HISTORIC PRESERVATION COMMISSION

Case #: HPC 2019.085
Date: November 19, 2019

PRESERVATION STAFF REPORT

Site: 33 Warren Avenue

33 Warren Avenue – 2017 Google photo

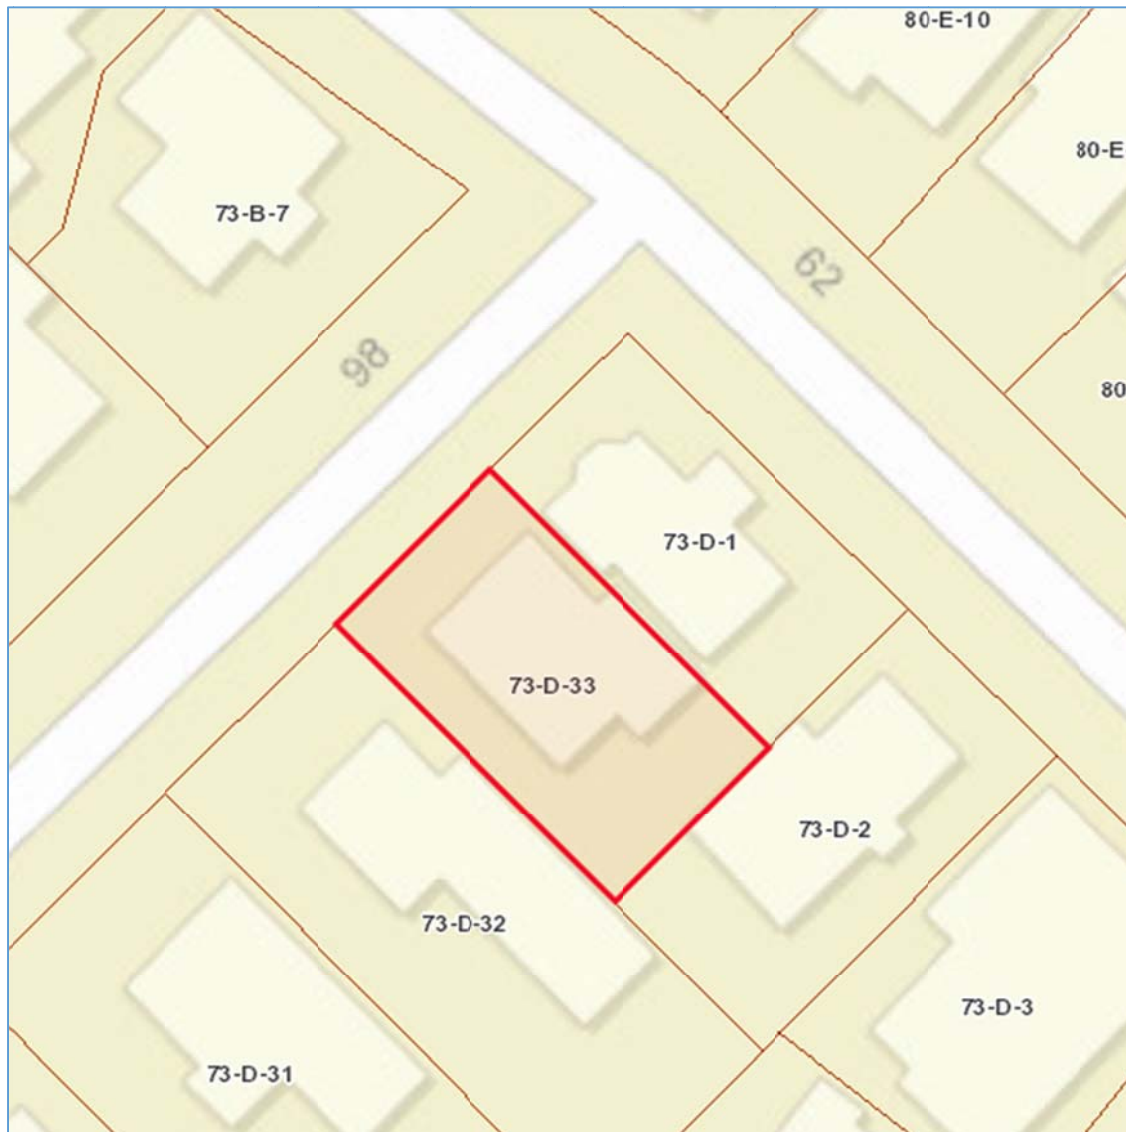
It is sided with asbestos shingles over the original clapboard. Investigations have shown that the house was clapboard with turned rope wood corner boards as can be seen on several other buildings in the neighborhood. Very little maintenance has been undertaken.

The windows in the attic have replaced with aluminum sliders. The remaining windows appear to be the original wood. Several windows have rotted sills. Many of the basement windows are missing and boarded up. A ground floor on the left side bay toward 58 Columbus Avenue has been blinded. This window is minimally visible from Warren Street due to its proximity to the adjacent house on

Columbus Avenue. A second floor window on the opposite bay, second floor is also blinded and much more visible. A highly visible fire escape runs down the back of the building from the attic to the ground. There is a skylight to the front of the chimney visible from uphill Warren Avenue and Columbus Avenue.

400 Series Double-Hung Window

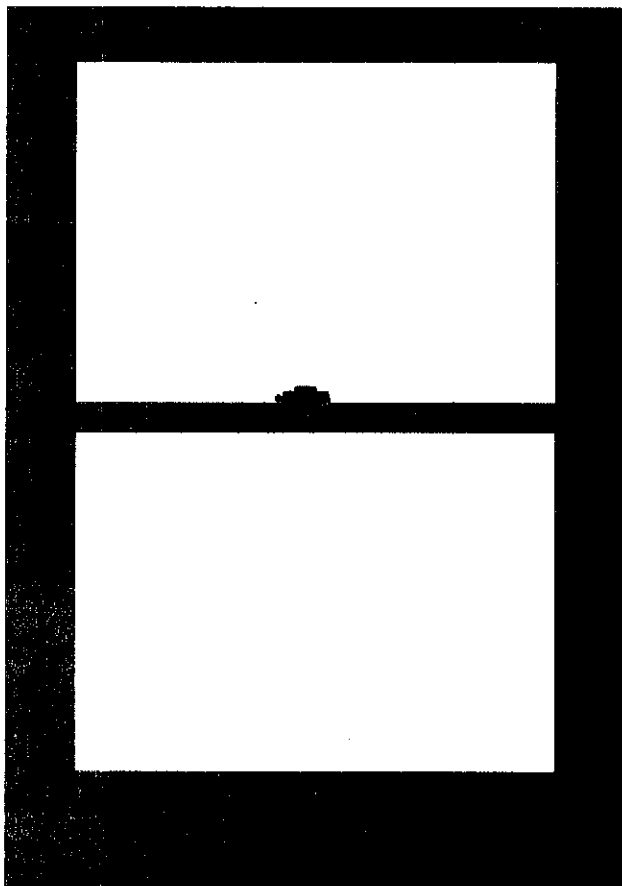
However the Staff finds that the replacement of the historic wood windows with Andersen 400 Series double-hung windows are not in-keeping with the Guidelines. It is not known what type of low-E glazing might be used. The Andersen windows have double glazing, no muntins and vinyl clad exteriors. It is also not known from the information provided as to whether the proposed replacement windows have the same proportions as the existing wood windows and how they would be installed within the casings for minimal visibility. Staff recommends that a Certificate of Appropriateness not be issued for the proposed windows.

A Certificate of Appropriateness should be issued to replace the attic windows with double-hung wood windows to fit the original opening to match the remaining existing double-hung windows; and replacement of the basement windows to match the existing. A Certificate of Non-Applicability may be issued for the repair of the original wood windows.
